AGENDA
City of Gig Harbor Design Review Board
Virtual Meeting of April 8, 2021 at 5:00 pm

**COMMUNITY DEVELOPMENT DEPARTMENT
PLANNING DIVISION
STAFF REPORT**

RE: Canterwood Commercial Center (PL-SPR-07-0004, PL-CUP-13-0002, PL-DRB-07-0013, PL-SEPA-07-0060)
Public Meeting Date: April 8, 2021

TO: Design Review Board
FROM: Planning Staff – Kimberly Mahoney, Associate Planner
DATE: April 1, 2021

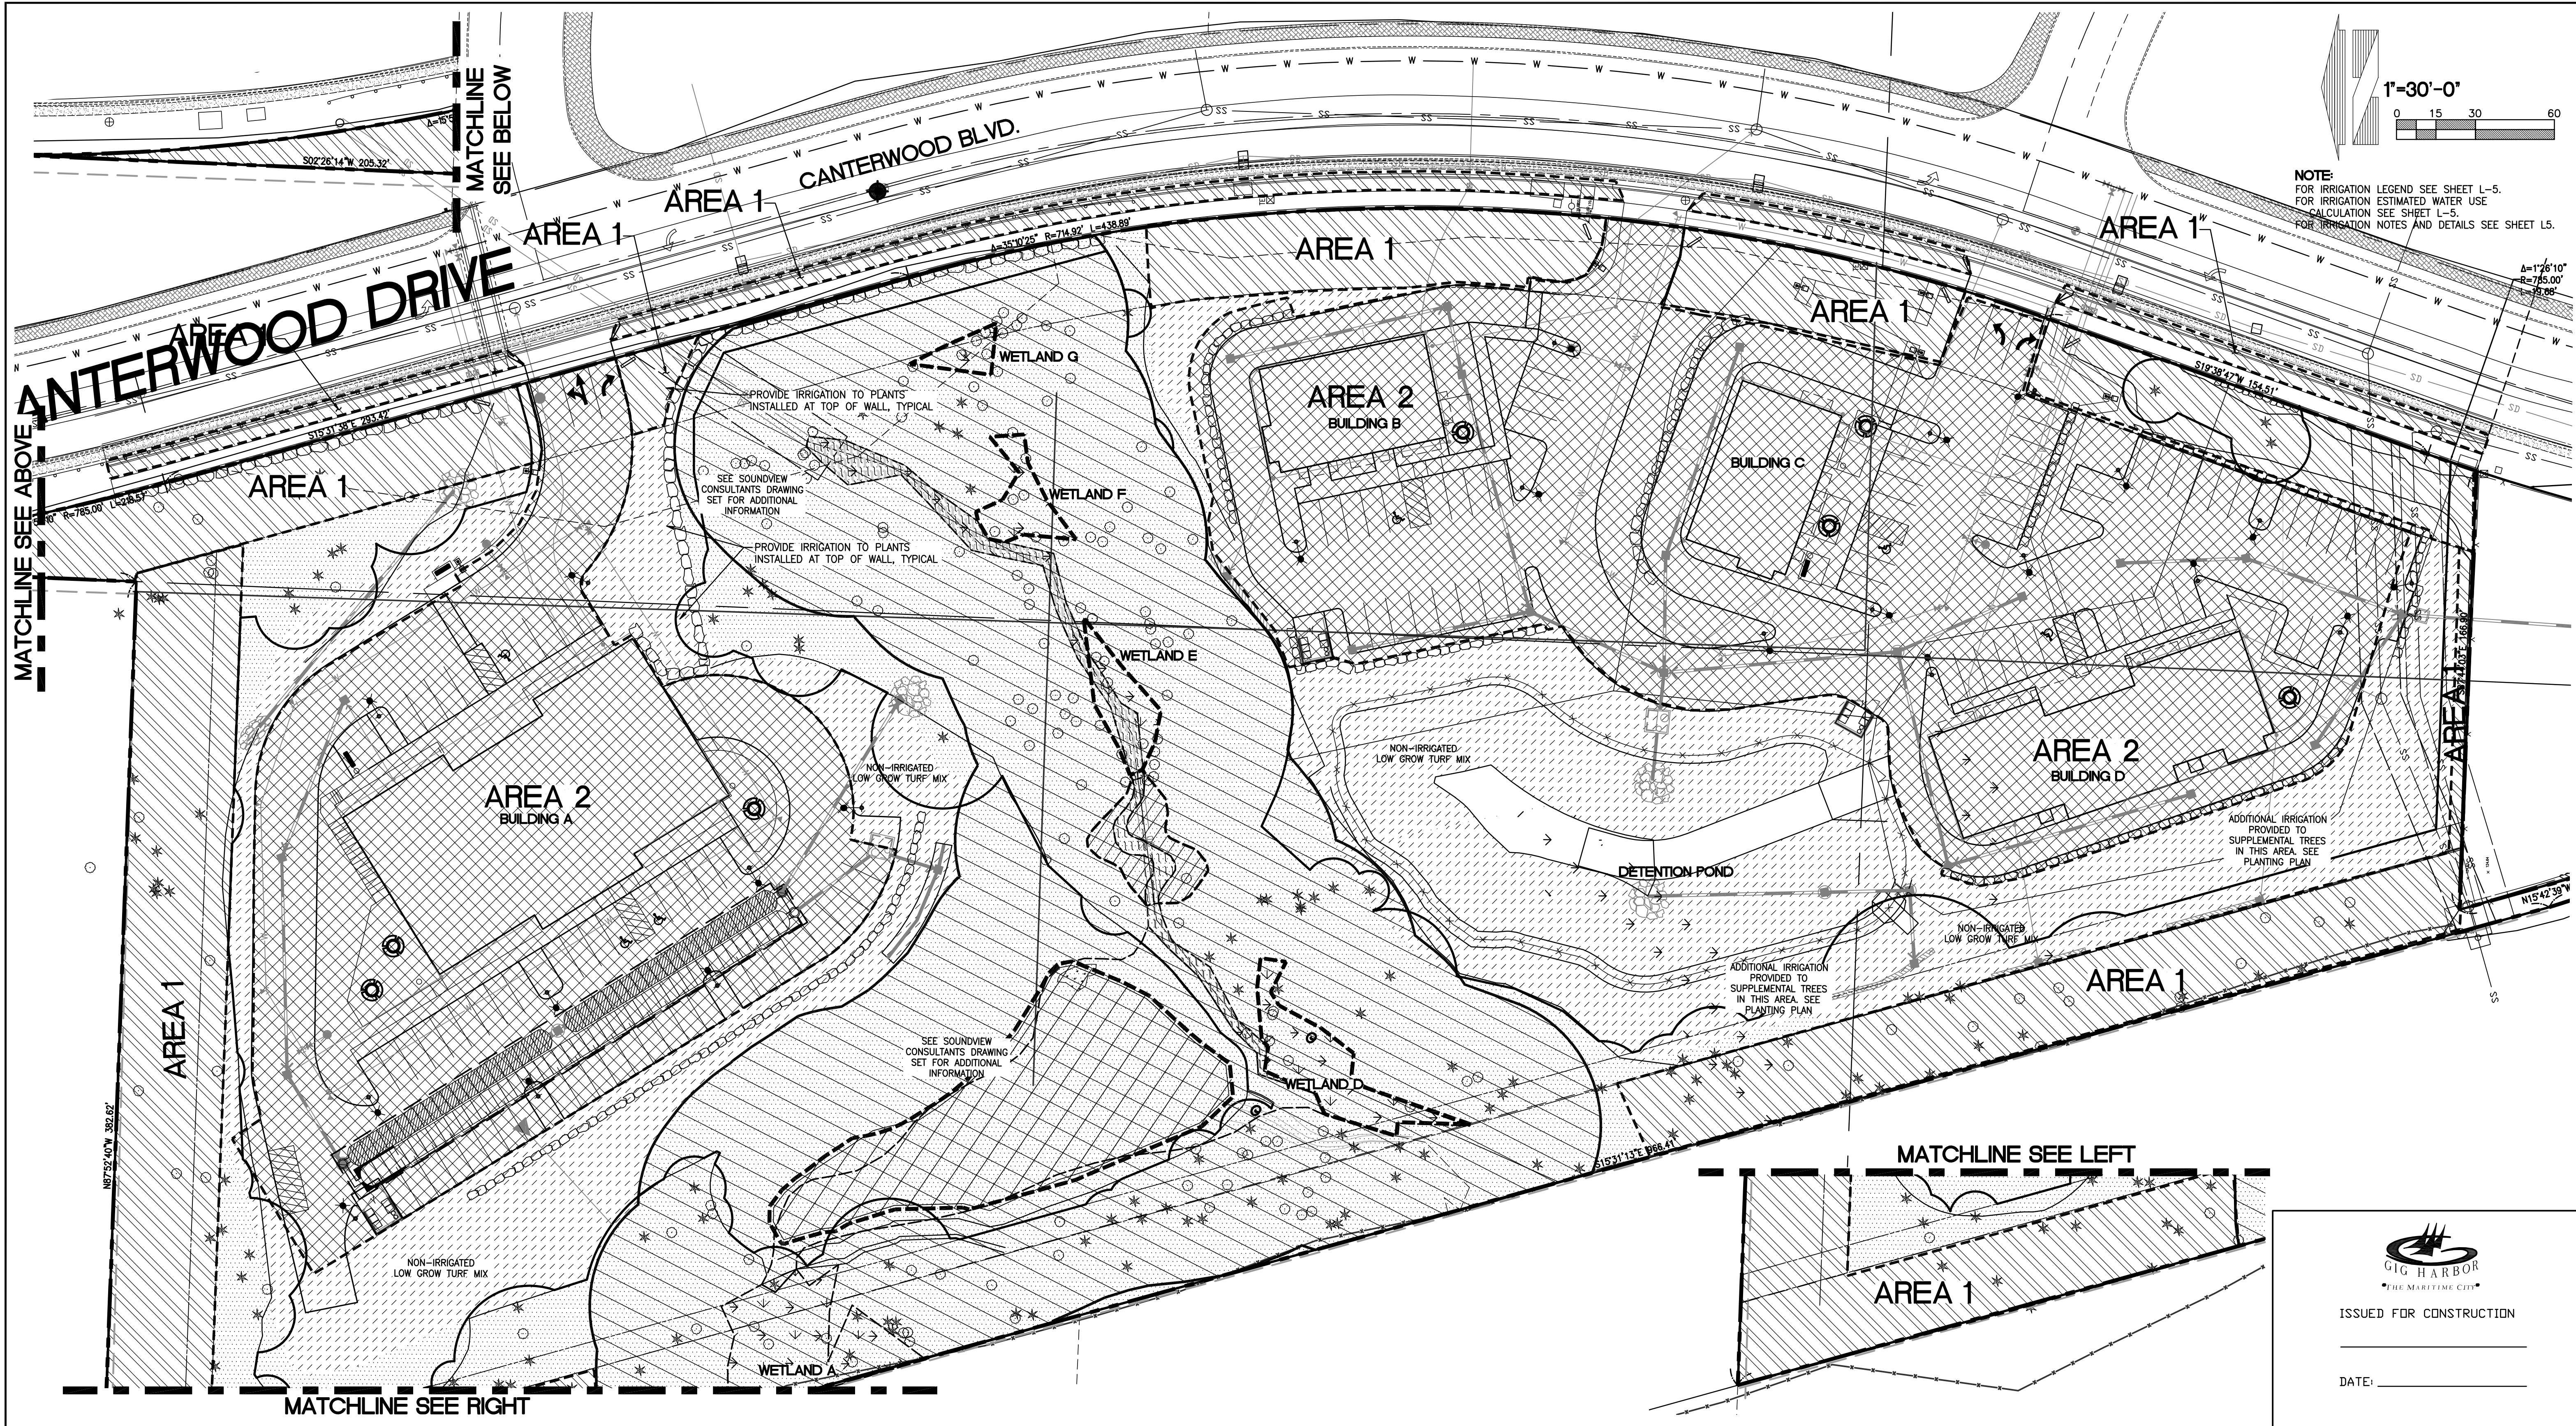
As an alternative to the requested removal of these two trees, the applicant is proposing to install 35 coniferous evergreen trees 6' tall at planting. The proposed planting schedule provides that these 35 trees will consist of Sitka Spruce (*Picea sitchensis*), Douglas Fir, and Western Red Cedar (*Thuja plicata*) trees. The replacement trees are proposed to be located on the west side of the parcel, separating Building D and the stormwater detention facility from State Route 16. Please see the highlighted area on Sheet L-1 of Exhibit B to reference the applicant's proposed location of the replacement trees and Exhibit A for the applicant's detailed narrative discussing the subject request.

The applicant is proposing to remove two (2) existing significant trees within the Canterwood Blvd. Enhancement Corridor and proposes to plant 35 coniferous evergreen trees 6' in height at planting near the western property line's frontage against SR-16.

EXISTING TREE INVENTORY PLAN	
CANTERWOOD COMMERCIAL CENTER GIG HARBOR	
PERMIT NO.	
DRAWING NO.	
SHEET	OF
L-6	8

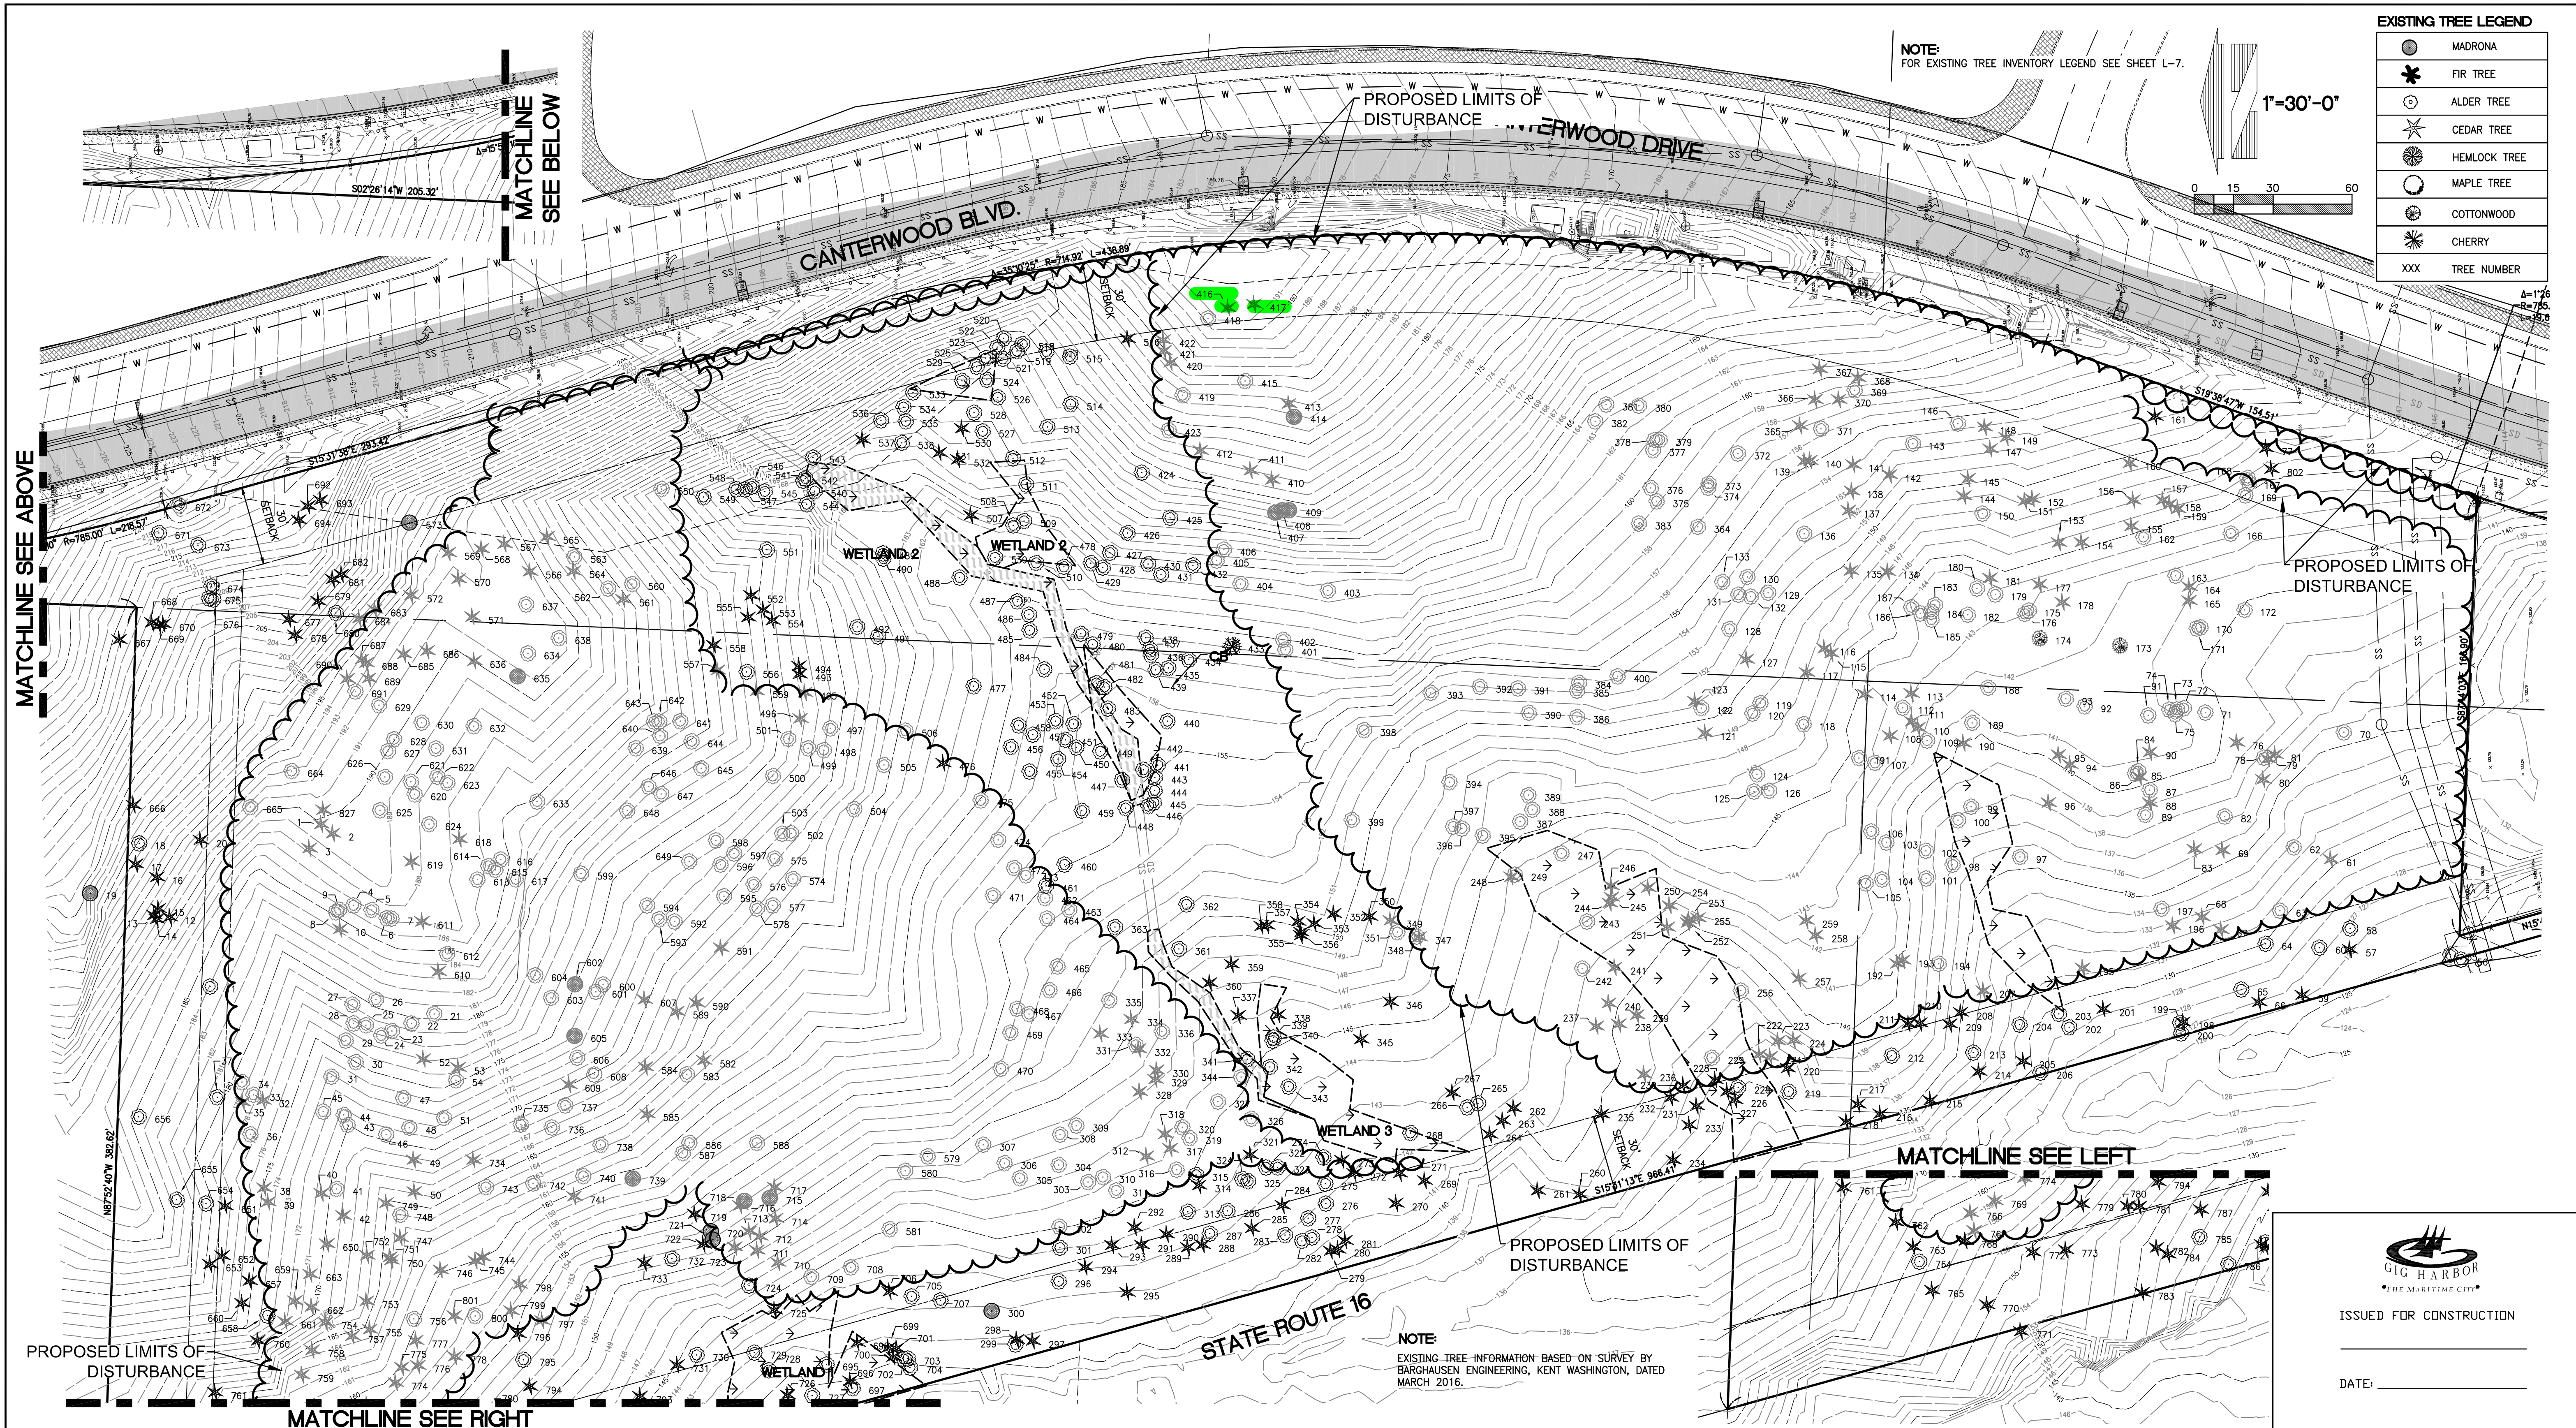
1. **Applicant's Request:** The applicant is requesting the DRB review and recommend approval of its proposal to remove two (2) existing significant trees within the Canterwood Blvd. Enhancement Corridor (the location of these two trees is highlighted on Sheet L-6 of Exhibit B) due to grading in close proximity to the trees necessary for site development. The trees to which this request is subject are identified as Trees #416 and #417 on the applicant's landscape plans (Exhibit B). Tree #416 is a Douglas Fir (*Pseudotsuga menziesii*) tree measuring 18" in diameter, and Tree #417 is a Douglas Fir tree measuring 17" in diameter.

While trees #416 and #417 are significant trees in an enhancement corridor and are therefore required to be retained, the proposed planting of 35 evergreen trees which may exceed a height of 150-feet at maturity suggests that the proposed alternative design will achieve a superiorly landscaped site. In particular, the selected location of the replacement trees is adjacent to the 30-foot-wide SR-16 Enhancement Corridor and will therefore create an even denser screen along SR-16, reducing the site's visibility from highway motorists and preserving the natural appeal of the site's eastern frontage. In this manner, and given the applicant's rendering of the subject site's frontage along Canterwood Blvd. (see Exhibit D) exhibiting regard for Gig Harbor's scenic beauty intended by an Enhancement Corridor, the DRB may wish to consider the proposed alternative design as equivalent or superior to the specific requirement outlined in GHMC 17.99.160(A). As the DRB shall consider the specific requirement as an appropriate example of compliance with the intent of the provision's general requirement, the DRB may wish to consider the proposed alternative's equivalence to the provision's specific requirement as a de facto compliance with the intent of the general requirement.
